**Huddersfield hotel  
 Huddersfield**

Project No. 2019 Enquiry 46	Project Title proposed first floor	Scale 1:200 @A2 size	Date 2/08/2020
Drawn By 114	Reviewed By MC	Reviewed Title	Revision K

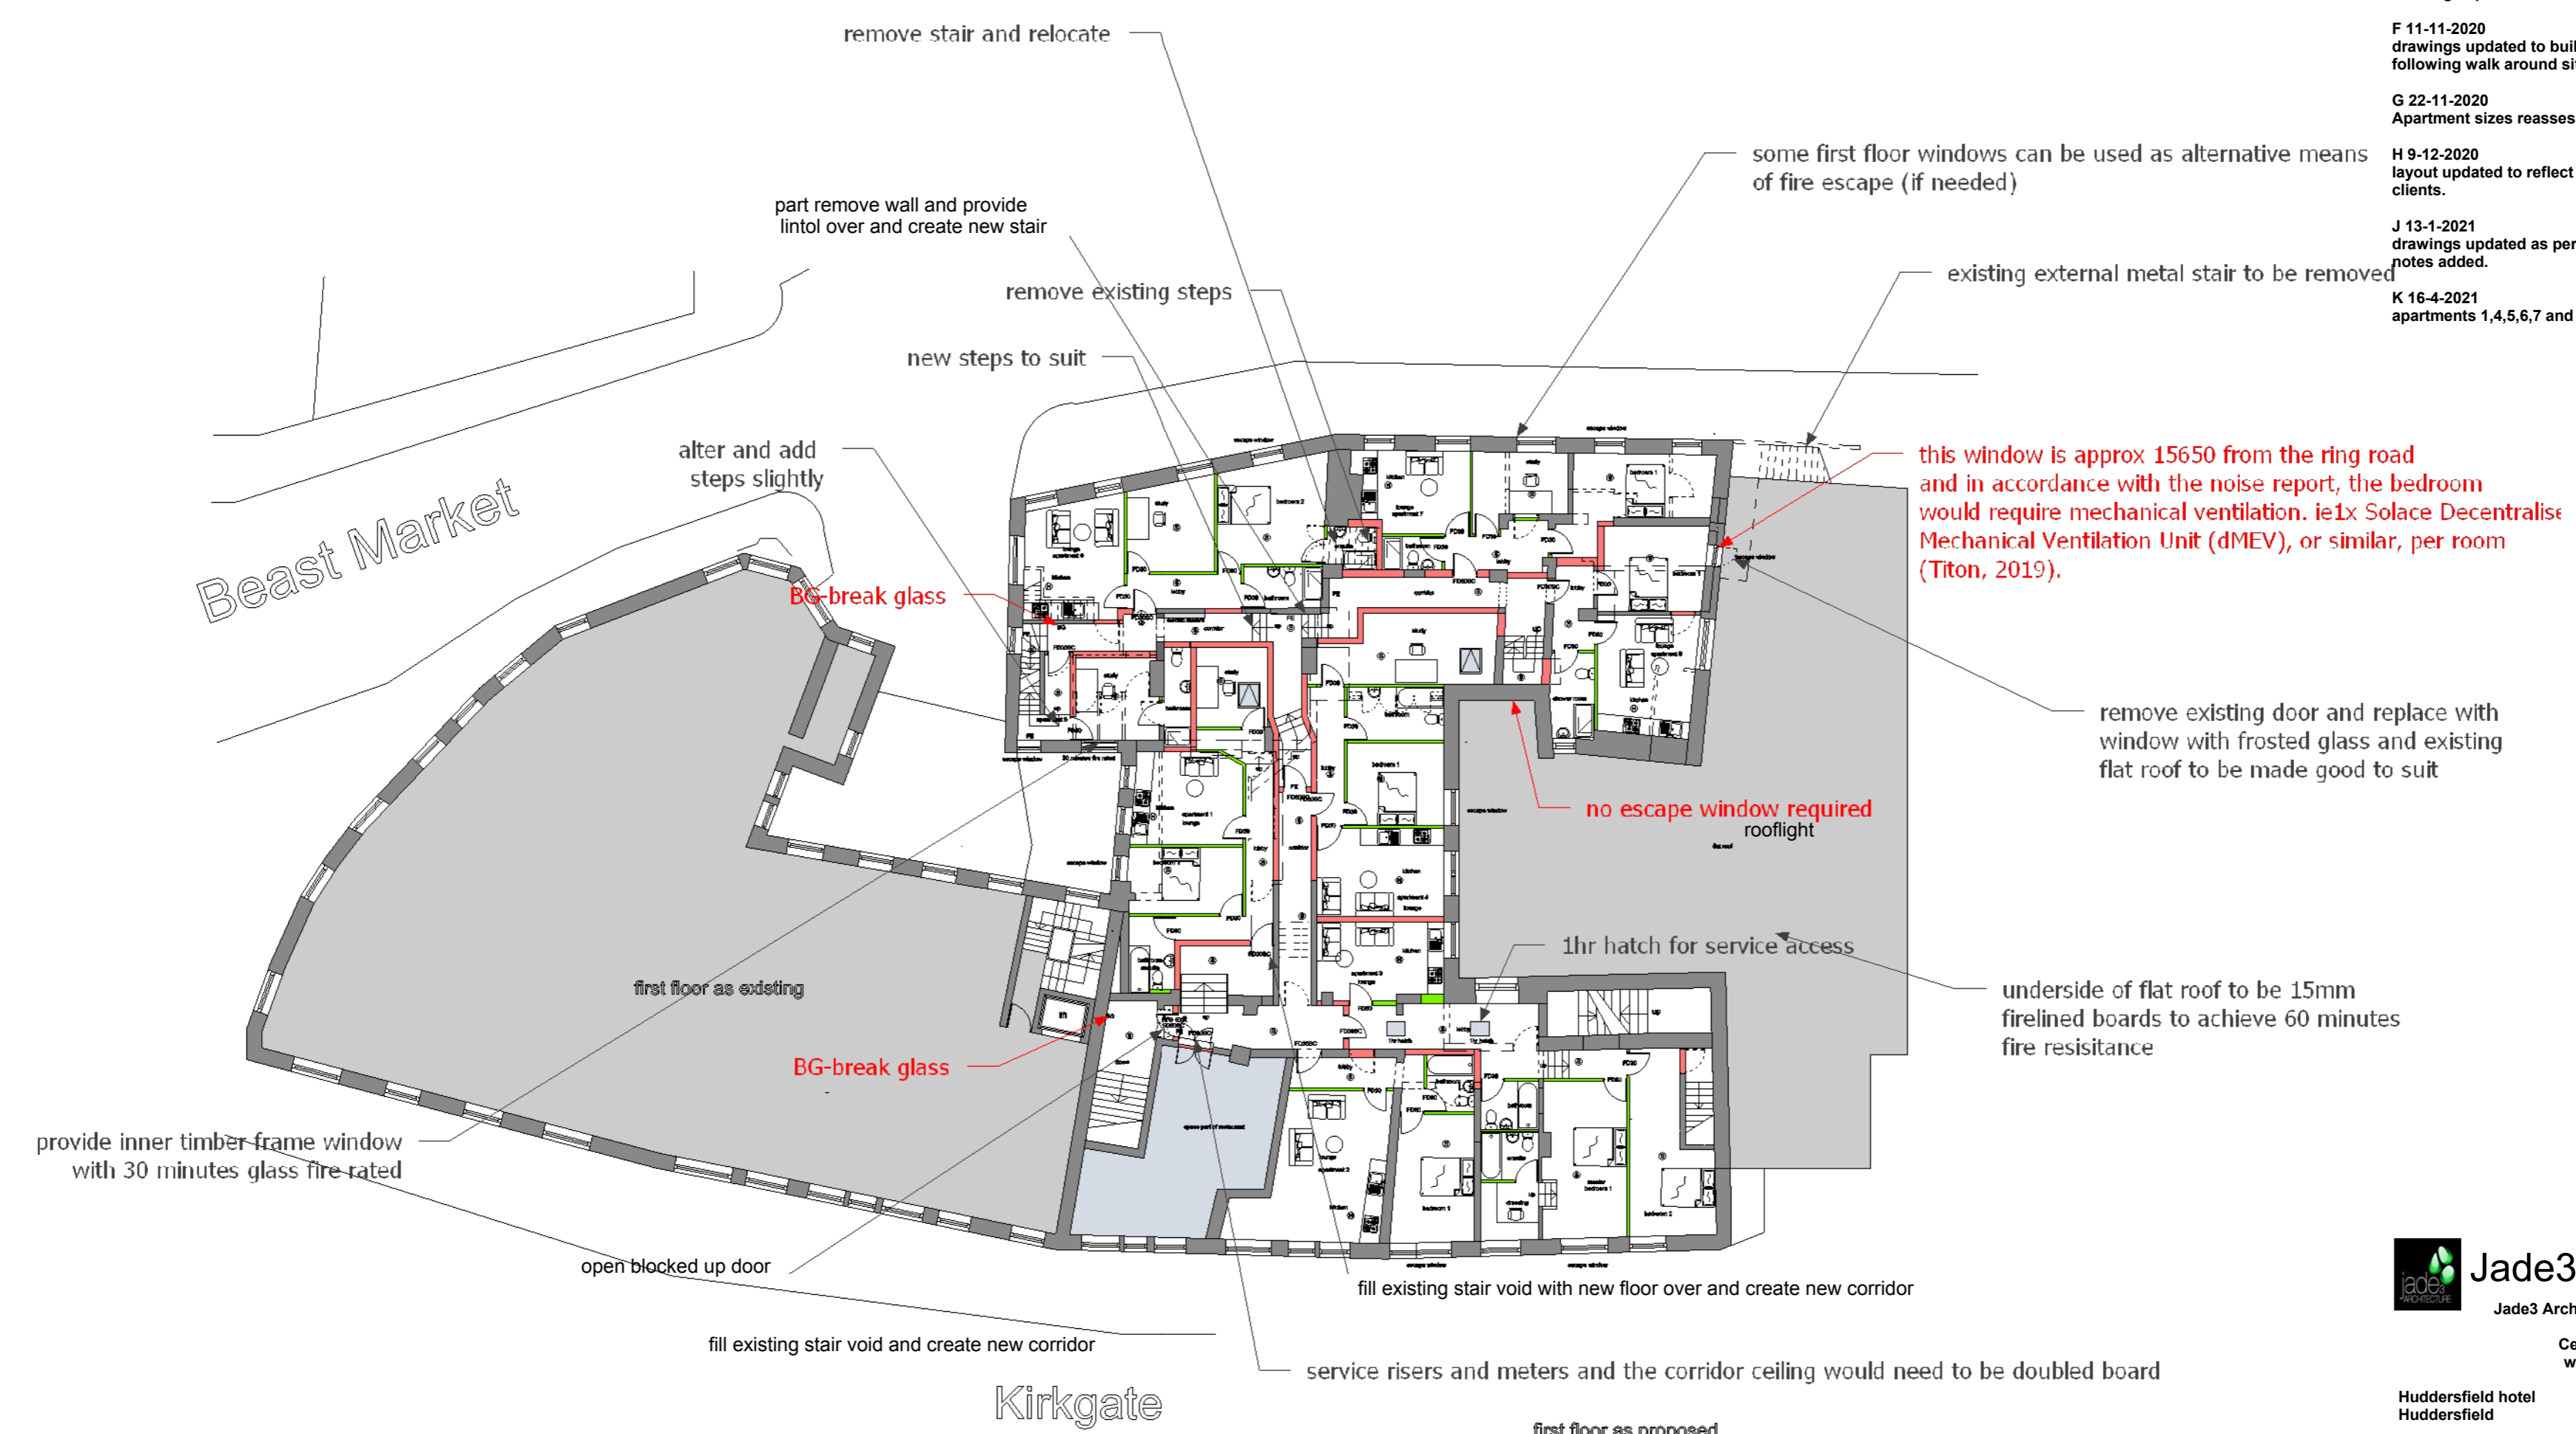
- Revisions  
 A 7-8-2020  
 Drawings updated.
- B 11-8-2020  
 Drawings updated to clients requirements. apartment 8 updated with entrance brought closer to stair and existing stair omitted and floored over.
- C 13-8-2020  
 external metal escape stair removed. Apartments 1,2,3,4 and 6 redesigned to suit
- D 27-9-2020  
 drawings updated to suit clients site visit on 25-9-2020
- E 5-11-2020  
 drawings updated
- F 11-11-2020  
 drawings updated to building control requirements following walk around site on 11-11-2020
- G 22-11-2020  
 Apartment sizes reassessed
- H 9-12-2020  
 layout updated to reflect site visit with building control and clients.
- J 13-1-2021  
 drawings updated as per visit with building control. Additional notes added.
- K 16-4-2021  
 apartments 1,4,5,6,7 and 8 updated to planners requirements.

**Note**  
 It has been agreed with building control that since all the first floor has escape windows, there is no need for AOV within the corridors.

The escape window to the attic stair is not required and is now omitted.

the window facing the ring road in apartment 7 is approx 15650 from the ring road and in accordance with the noise report, the bedroom would require mechanical ventilation. ie 1x Solace Decentralised Mechanical Ventilation Unit (dMEV), or similar, per room (Titon, 2019).

1no break glass each added to final exit of both stairs only, no sounders as its a stay put policy.

fire alarm to be linked back to the hotel

fire exit stickers to be provided to the attic rooflights

no external stair needed for fire escape as it is within 4500 high from the external ground level.
